Providence City Plan Commission

AGENDA ITEM 9 ■ 36 BERLIN STREET

Proposed subdivision

CASE NO./PROJECT TYPE: 20-030 UDR—Unified Development Review

GEORGE B. DUPONT P.L.S.					
MINOR SUBDIVISION					
SURVEY AND PLOT PLAN					
DRAWN BY STEPHEN WILDENHAIN		APPROVED BY	APPROVED DATE	DATE 3/7/20	SCALE 1' = 30'-0"
36 BERLIN STREET PROVIDENCE, RI ASSESSORS PLAT 65 LOT 376		OWNER VINCENT MANN		EDITION 1	SHEET 1 OF 1

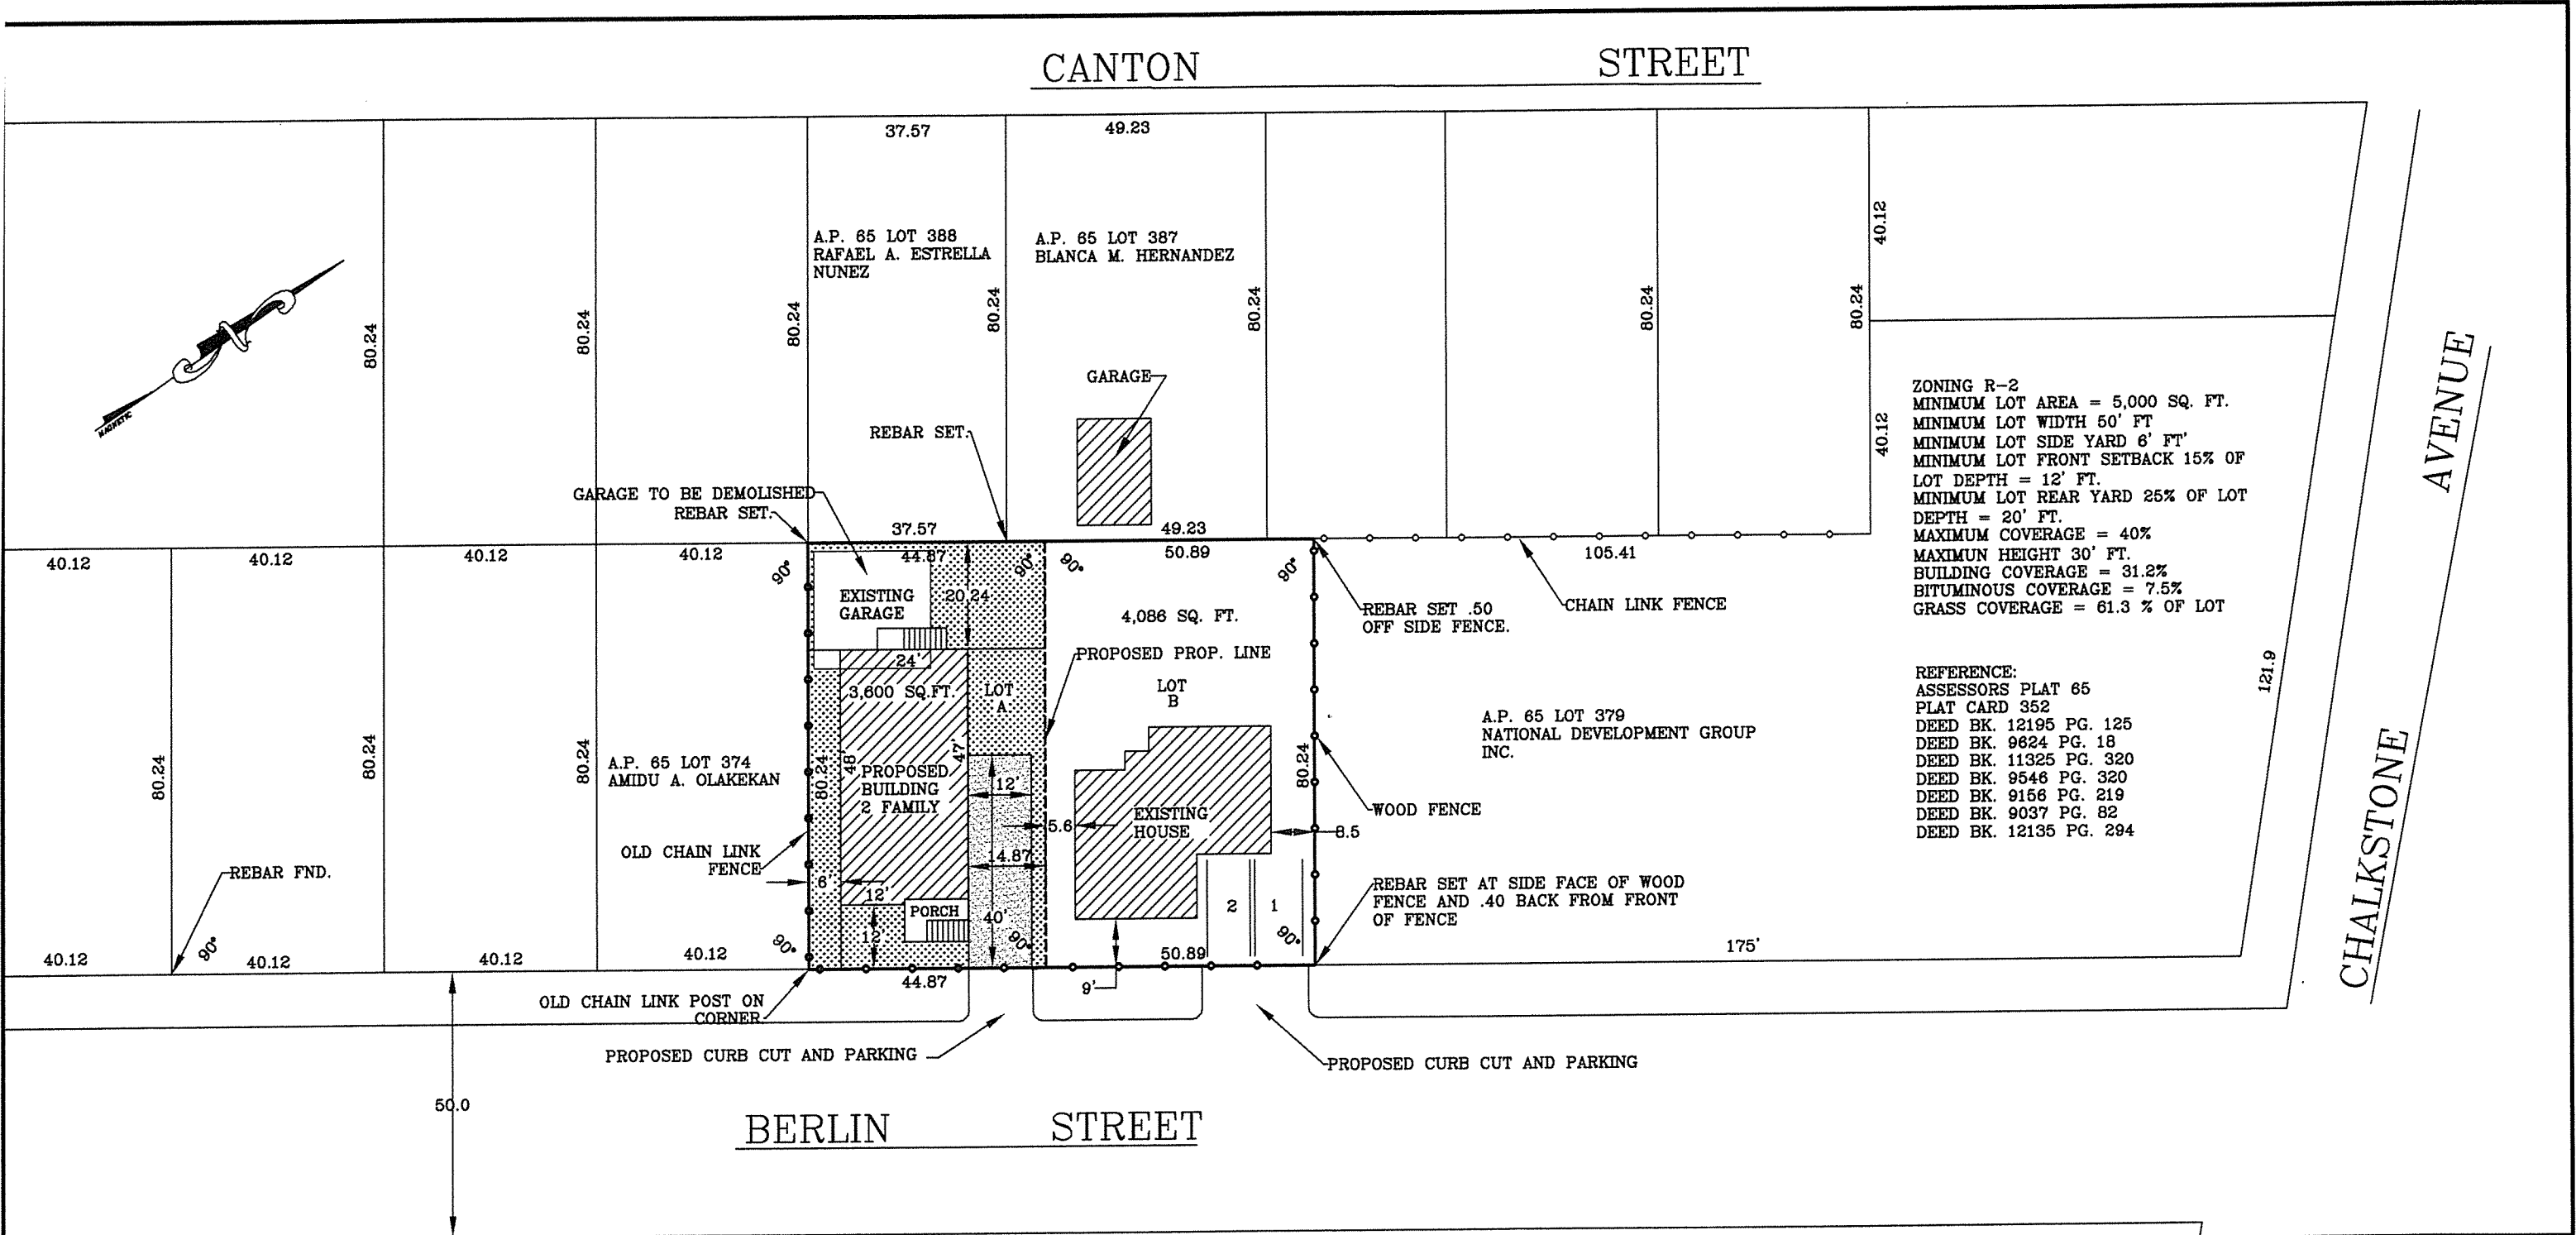
The subject property is occupied by a single family dwelling and measures approximately 7,686 SF. The applicant is proposing to subdivide the lot into two lots of 4,086 SF (Lot A) and 3,600 SF (Lot B) with respective widths of 50.89' and 44.87'. A two family dwelling is proposed on Lot B and the existing single family dwelling will remain on Lot A. The minimum required lot size for new subdivisions in the R-3 zone is 5,000 SF with a width of 50 feet. Pursuant to Unified Development Review (UDR), the applicant is seeking dimensional variances from provisions related to minimum lot area and minimum lot width in table 4-1 of the ordinance. A variance from the side yard setback requirement is requested where a side yard setback of 6' is required but 5.6' will be provided between the proposed lot line and the existing house. In addition, the applicant is seeking relief from the total maximum impervious surface coverage requirement, front yard maximum impervious surface requirement, front yard setback, and maximum driveway width.

Relief from curb cut width and the amount of front yard impervious surface coverage is being requested because parking for the existing house is proposed in the front yard for two vehicles. Relief from the front yard setback is also requested, but there is no apparent reason for why the applicant can't meet this requirement. These requests cannot be attributed to the character of the property as it is possible for the applicant to bring the site into closer compliance with the ordinance by reducing the magnitude of relief requested.

The relief requested is the least relief necessary to create separate lots to maintain a single family dwelling with a setback of 5'6" and create a lot for development of a two family dwelling with a width of 44.8'. The relief requested for curb cut width, front yard setback, and paving in the front yard is not the least relief necessary. Only one parking space, and therefore less paving and a narrower driveway is required for the existing single family dwelling. The relief for these items is not the least necessary as the applicant could reduce the magnitude of relief requested to bring the site into closer conformance with the plan. The applicant will conform to all the other zoning requirements.

The other requested variances for front yard paving, driveway width and front yard setback should be denied, finding that they do not meet the criteria for a variance.

Based on the analysis and findings contained in this report, the CPC should approve the subdivision having granted relief for minimum lot size, minimum lot width and side yard setback. The requests for relief from the front yard setback requirement, front yard paving and maximum driveway width should be denied. The CPC should grant preliminary plan approval to a plan that conforms to the ordinance based on the relief granted and subject to the following conditions:
